Access Compliance Report

Public Rights-of-Way

Intersection ID: 7270	Main Street: CANTERWOOD_DR	Cross Street: TOM_HUNTER_RD	Location: SE
ADA ID: 2CFABB32D3A0	Ramp Type: PerpDiag	Initial Pass/Fail: Fail	Overall Compliance: No
Severity Score: 8.75			
Codes/Mitigation Info/Possible Solution		Field Measurements/Component Compliance

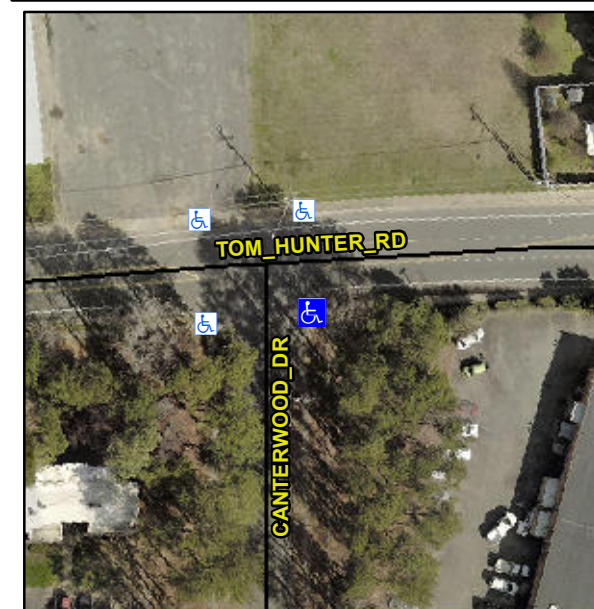
Not Found, R304.5.1

Compliance	Description	Data	Compliance	Description	Data
N/A	Ramp Length (in)	49.0	Yes	Ramp Slope (%)	8.0
No	Ramp Width (in)	47.5	Yes	Ramp XSlope (%)	0.2
N/A	Flare Type LT	N/A	N/A	Flare Type RT	N/A
N/A	Flare Slope LT (%)	N/A	N/A	Flare Slope RT (%)	N/A
N/A	Flare Traversable LT?	N/A	N/A	Flare Traversable RT?	N/A
N/A	Landing Length (in)	N/A	N/A	DWS Provided?	N/A
N/A	Landing Width (in)	N/A	N/A	DWS Contrast?	N/A
N/A	Landing Slope (%)	N/A	N/A	DWS Length (in)	N/A
N/A	Landing X Slope (%)	N/A	N/A	DWS Full Width?	N/A
N/A	Landing Curb? (Y/N)	N/A	N/A	DWS Offset (in)	N/A
N/A	Shared Landing?	N/A			
N/A	Gutter Ponding?	N/A	N/A	Gutter Slope (%)	N/A
N/A	Gutter Lip Ht (in)	N/A	N/A	Gutter X Slope (%)	N/A
N/A	Painted X Walk1?	No	N/A	Painted X Walk2?	No
	X Walk 1 Direction	To NE		X Walk 2 Direction	To SW
N/A	X Walk 1 Width (in)	N/A	N/A	X Walk 2 Width (in)	N/A
	X Walk 1 Slope (%)	2.9		X Walk 2 Slope (%)	2.5
	X Walk 1 X Slope (%)	0.1		X Walk 2 X Slope (%)	1.9

Remove & Replace Curb Ramp With Two New Directional Ramps or Equivalent.
